# UNITED STATES PATENT AND TRADEMARK OFFICE

APPLICATION NO.	FILING DATE	FIRST NAMED INVENTOR	ATTORNEY DOCKET NO.	CONFIRMATION NO.
10/783,499	02/20/2004	George Gustave Zipfel JR.	Zipfel 1	7599

<b>Office Action Summary</b>	<b>Application No.</b> 10/783,499	<b>Applicant(s)</b> ZIPFEL ET AL.	
	<b>Examiner</b> Michael B. Shingleton	<b>Art Unit</b> 2815

## **DETAILED ACTION**

Basic Illustration 1.

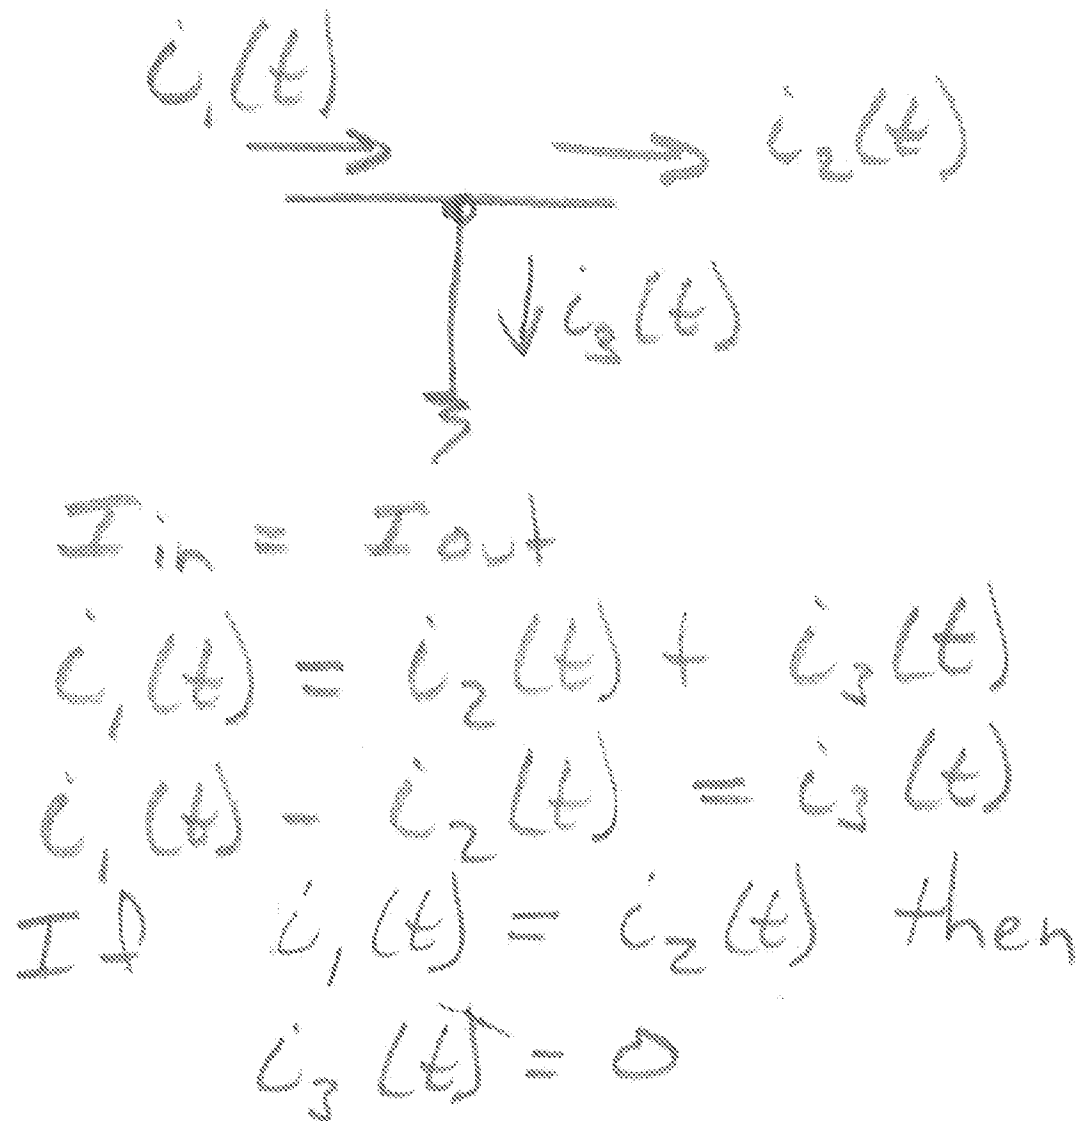
The examiner also feels that it is necessary due to applicant's remarks/arguments and to make clear to others some basic engineering features involved. It is just a common fact that in circuit analysis that a DC source acts as a short to an AC signal. So applicant's invention is more in tune to two separate push-pull or inverter arrangements that share a common ground. This is like separate light bulbs connected in parallel. Prokin also recognizes this fact in its illustration of Figure 11. The illustration below illustrates the basic arrangement of both Prokin and applicant's invention. See Basic illustration 1.

When the baseband currents are equal and opposite through the two loads then there is no baseband current through the “ground lead” as illustrated above. This is what occurs in Prokin and is the subject of the alternative description of the same function of the invention as presented in claim 9 and compared to claim 1. This fact that there is no current is based on the fact that the current into a node must equal the current out of the node, a basic engineering feature. With this then what flows into this node from one load is the current that flows into the other load. Again this is what happens in Prokin as

Figure 4a of the instant application.

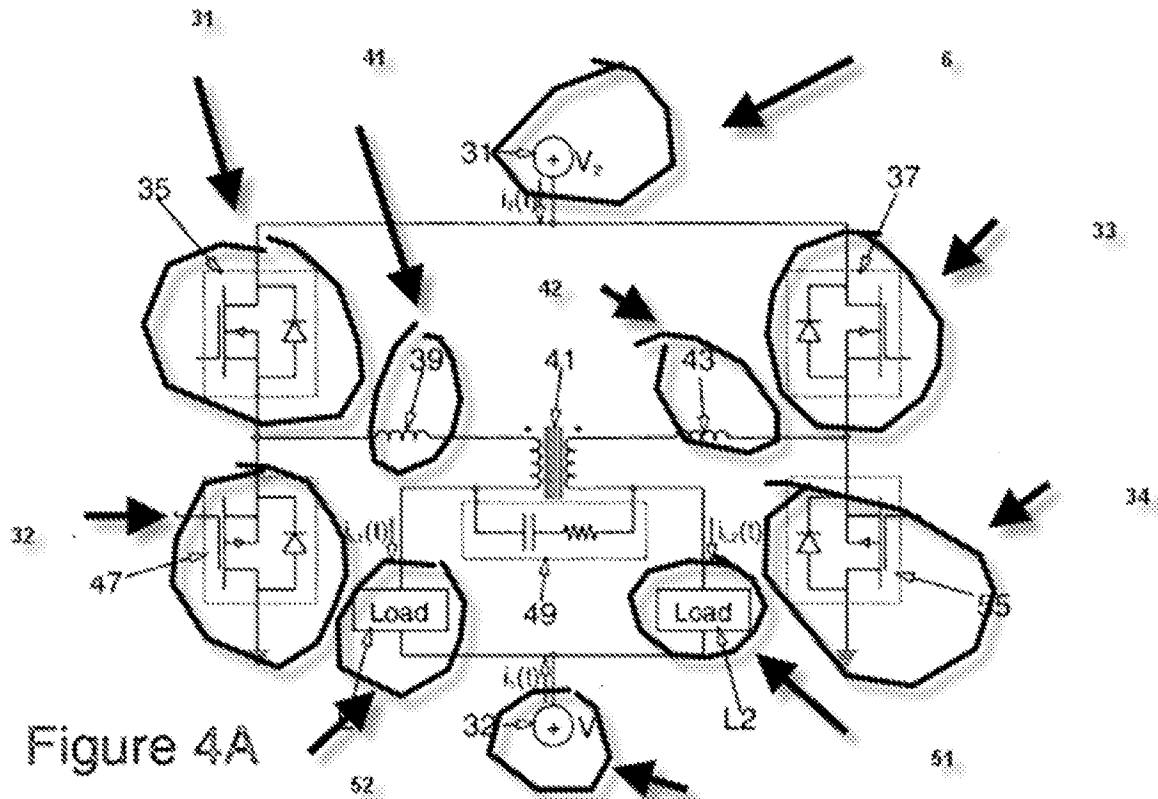
See elements 31 and 32 are part of the means that forms a first switching signal and elements 33 and 34 that forms a second switching signal of Prokin. Compare that to the disclosed invention of Figure 4a. The switching band component is the same as that of applicant's disclosed invention and that is a square-wave and as mentioned above the device of Prokin is for an audio function (It is to power voice

coils.) wherein the baseband component is applied by the pulse width modulation of the square-wave just like that of applicant's disclosed invention. (See Figure 4a of the instant application and Figure 15 of Prokin.)

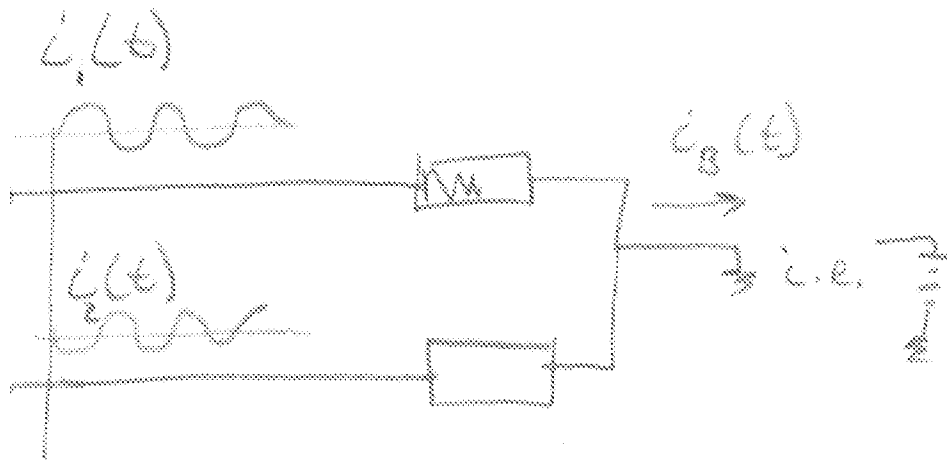
See the two wires that are used to apply the switching signals to the loads as illustrated above.

Speaker illustration number 1.

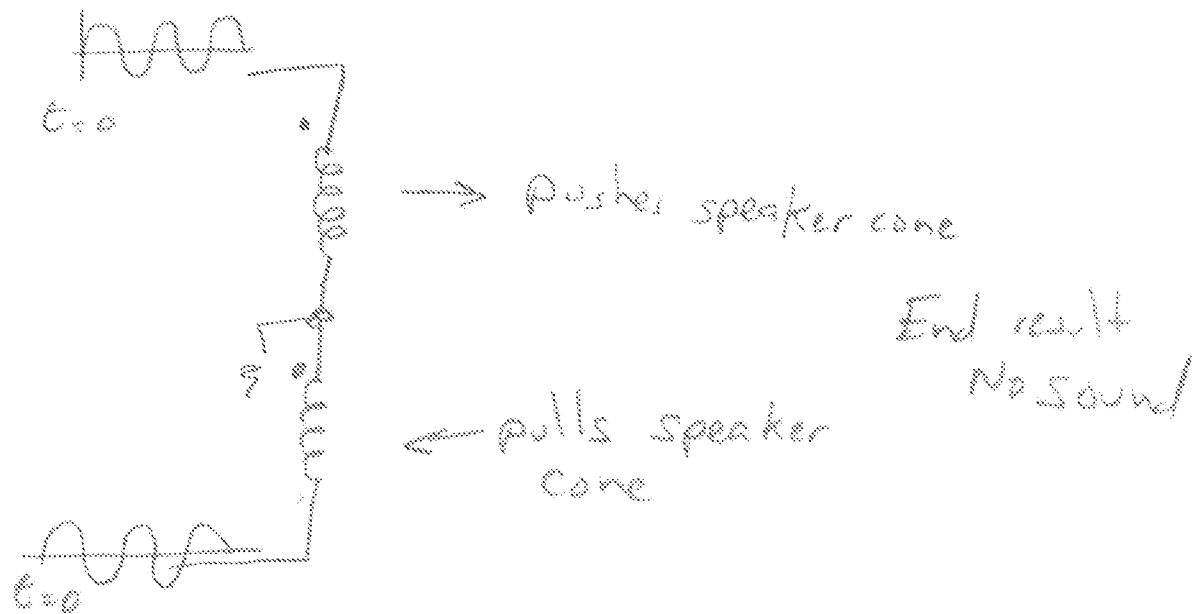
As noted above the baseband signals that are applied to the two loads in the Prokin prior art are out-of-phase just like that of applicant’s invention. This inherently exists because of the “alternative” switching of the inverter transistors in the Prokin arrangement as noted above and more particularly this is further supported by the fact that in one preferred embodiment of Prokin a dual coil speaker is used. Note the “dot convention” of Figure 15. If the base band signals were not complementary or of opposite phase then the speaker would not produce any sound as the voice coils would cancel each other out. See the drawing called “Speaker illustration number 1” below that should help applicant see this fact.

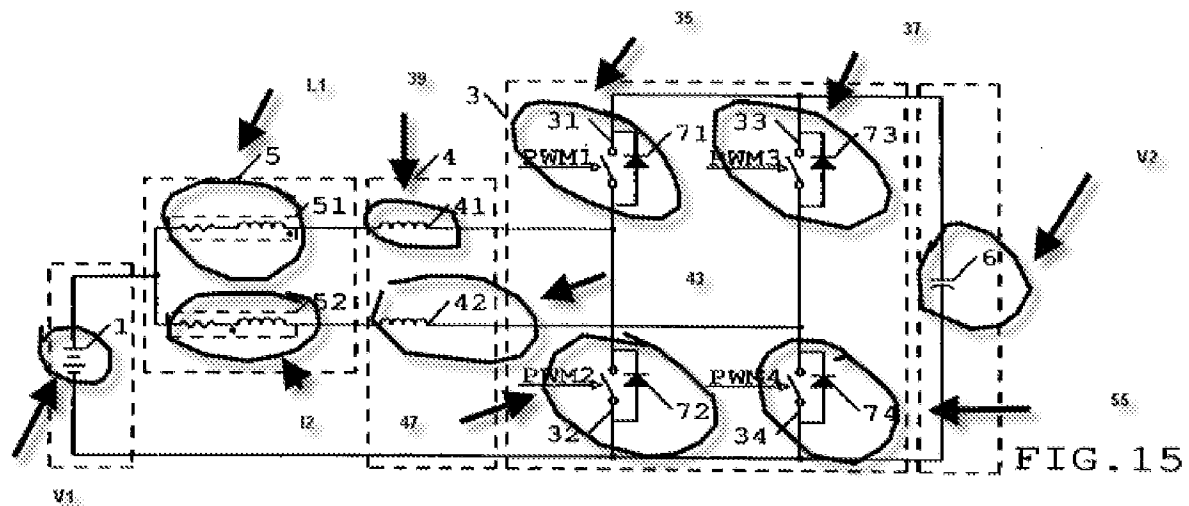
Above shows the elected invention of Figure 4a. The interconnected load for the switching amplifier is shown above. While the claims lack any detail of the switching amplifier (Just now referred to as just "apparatus" in some of the claims. The examiner has cited Prokin of record for the switching amplifier is the same as that noted above. Below the examiner has provided a copy of Figure 15 of Prokin.

As recited by Prokin the bridge capacitor 6 supplies the power for the switching amplifier (See the abstract and the relevant text in the specification of Prokin.). As one can see from the above drawings the switching amplifier of Prokin is the same structure as that of applicant's elected invention. Note the four transistors. Thus the claimed structure to the switching amplifier is anticipated by Prokin in so far as the claims are understood. Note that the switching amplifier has output lines to the interconnected load and thus these are means for applying the baseband components. Note the common power supply node of element 1 of Prokin. Note that the switching amplifier of Prokin has "at least one power supply terminal" in the bridge capacitor or element 1 as set forth by at least claim 14. The four transistors like that of applicant's four transistor structure switching amplifier produces an alternating polarity of currents (See claim 22 of the instant application.). The use of PWM signals do not define any switching amplifier structure but never the less Prokin has PWM signals applied to the four transistors that make up the switching amplifier structure. The output lines are the means for supplying the two switching signals to the interconnected load (See claim 24 of the instant application.) As stated in the previous office action, if one were to connect the interconnected load to the switching amplifier of Prokin this would result in the combination functioning exactly as that of applicant's combination of switching amplifier and

Basic Illustration 1.

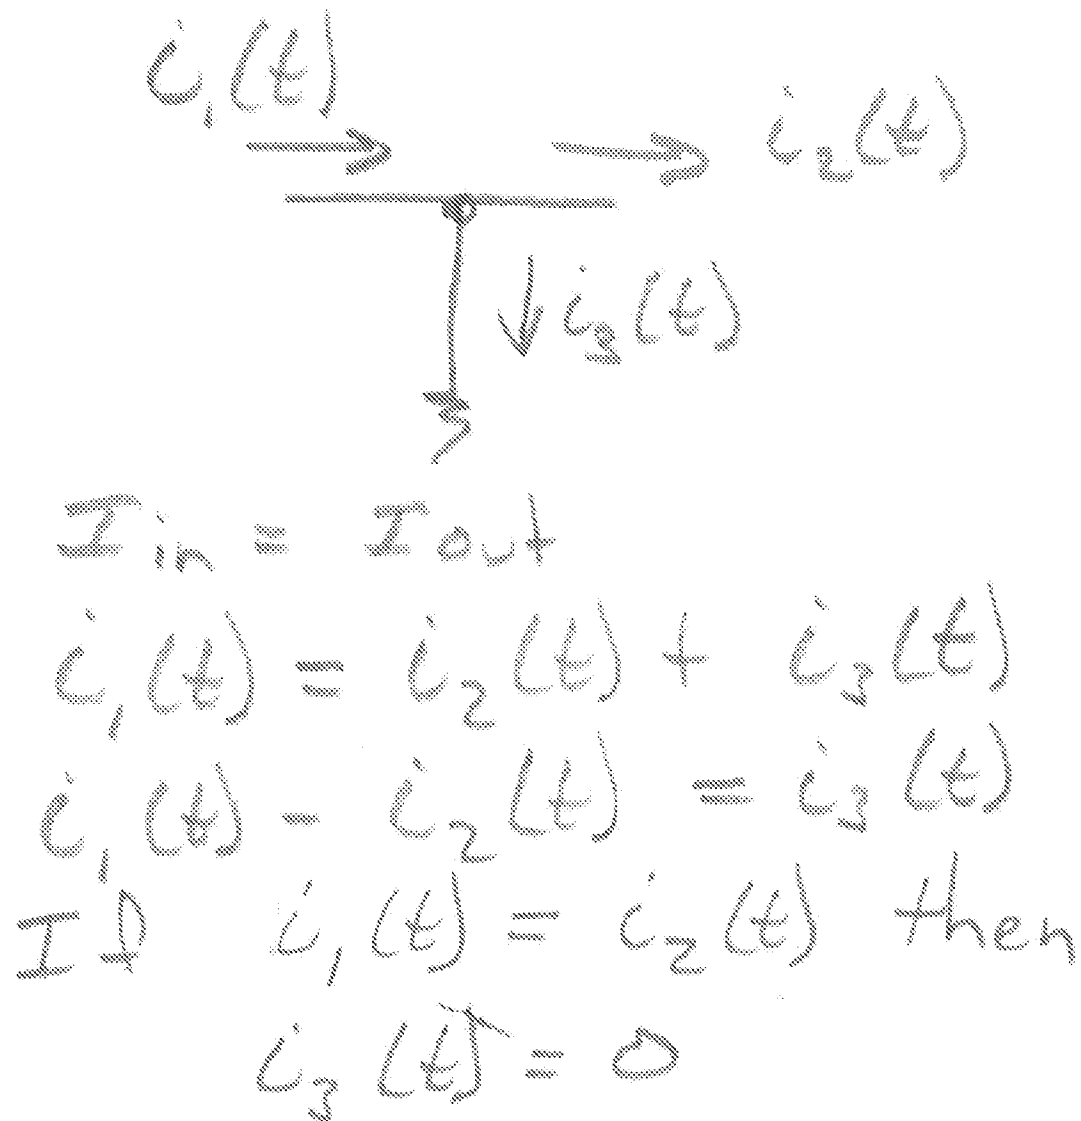
The examiner also feels that it is necessary due to applicant's remarks/arguments and to make clear to others some basic engineering features involved. It is just a common fact that in circuit analysis that a DC source acts as a short to an AC signal. So applicant's invention is more in tune to two separate push-pull or inverter arrangements that share a common ground. This is like separate light bulbs connected in parallel. Prokin also recognizes this fact in its illustration of Figure 11. The illustration below illustrates the basic arrangement of both Prokin and applicant's invention. See Basic illustration 1.

When the baseband currents are equal and opposite through the two loads then there is no baseband current through the “ground lead” as illustrated above. This is what occurs in Prokin and is the subject of the alternative description of the same function of the invention as presented in claim 9 and compared to claim 1. This fact that there is no current is based on the fact that the current into a node must equal the current out of the node, a basic engineering feature. With this then what flows into this node from one load is the current that flows into the other load. Again this is what happens in Prokin as

Figure 4a of the instant application.

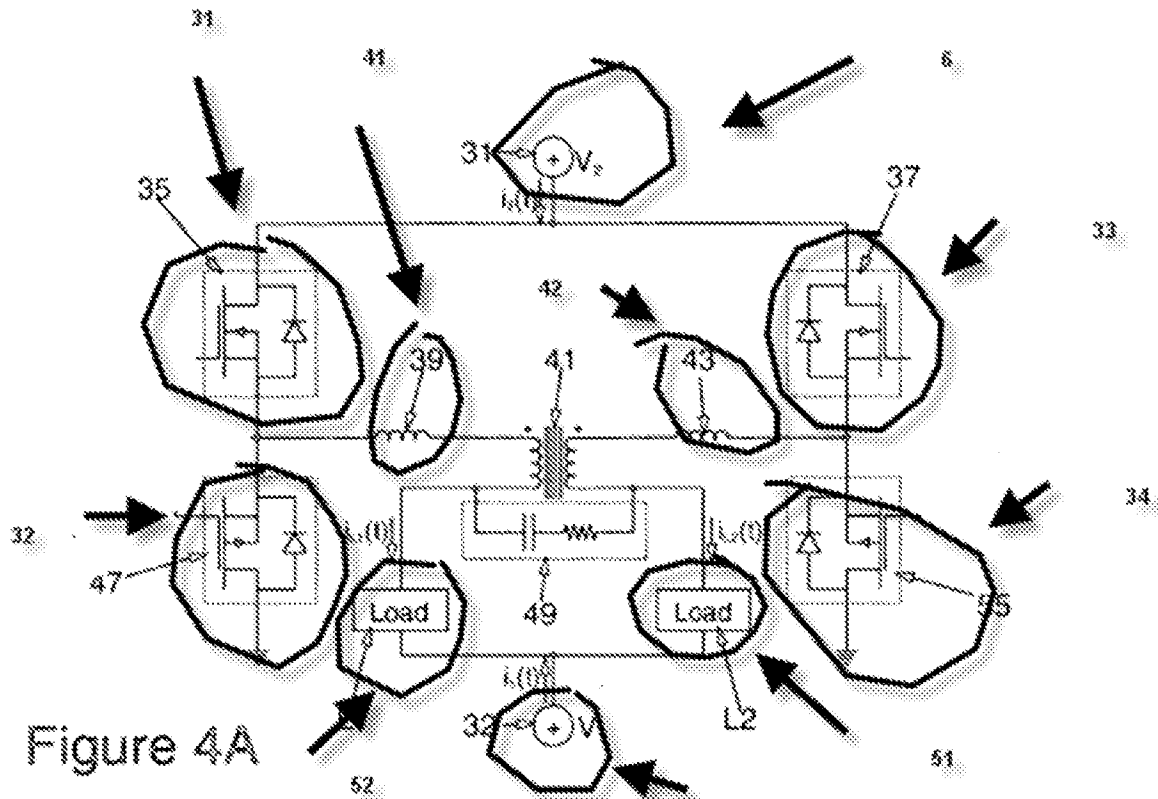
See elements 31 and 32 are part of the means that forms a first switching signal and elements 33 and 34 that forms a second switching signal of Prokin. Compare that to the disclosed invention of Figure 4a. The switching band component is the same as that of applicant's disclosed invention and that is a square-wave and as mentioned above the device of Prokin is for an audio function (It is to power voice

coils.) wherein the baseband component is applied by the pulse width modulation of the square-wave just like that of applicant's disclosed invention. (See Figure 4a of the instant application and Figure 15 of Prokin.)

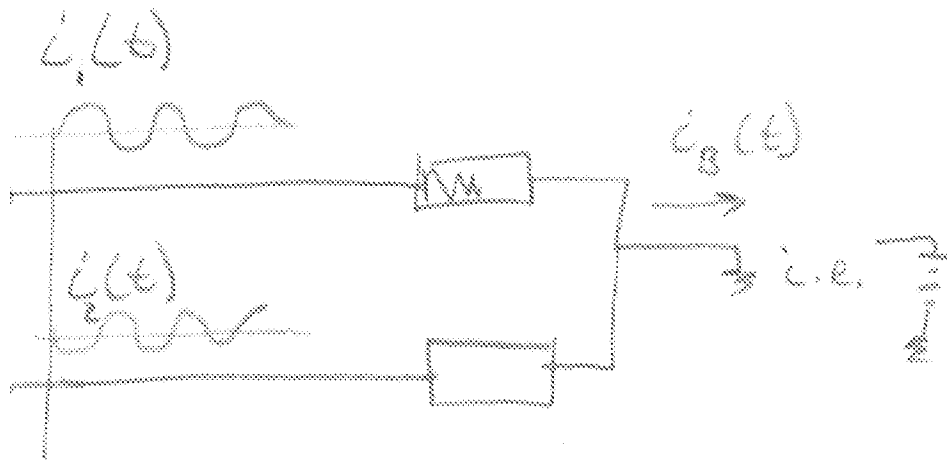
See the two wires that are used to apply the switching signals to the loads as illustrated above.

Speaker illustration number 1.

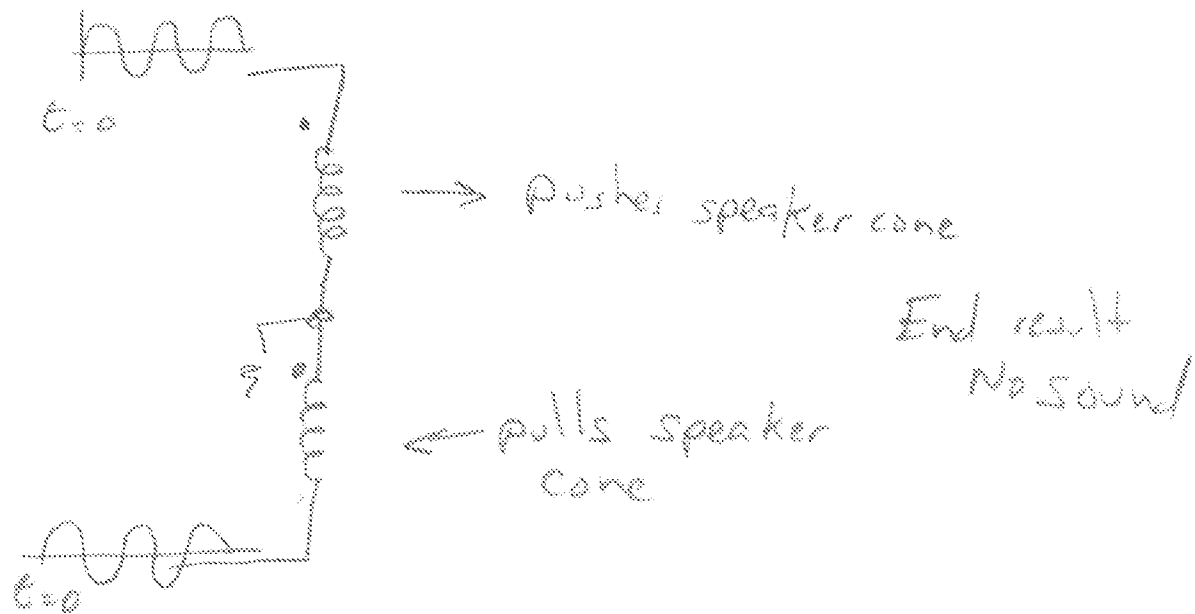
As noted above the baseband signals that are applied to the two loads in the Prokin prior art are out-of-phase just like that of applicant’s invention. This inherently exists because of the “alternative” switching of the inverter transistors in the Prokin arrangement as noted above and more particularly this is further supported by the fact that in one preferred embodiment of Prokin a dual coil speaker is used. Note the “dot convention” of Figure 15. If the base band signals were not complementary or of opposite phase then the speaker would not produce any sound as the voice coils would cancel each other out. See the drawing called “Speaker illustration number 1” below that should help applicant see this fact.
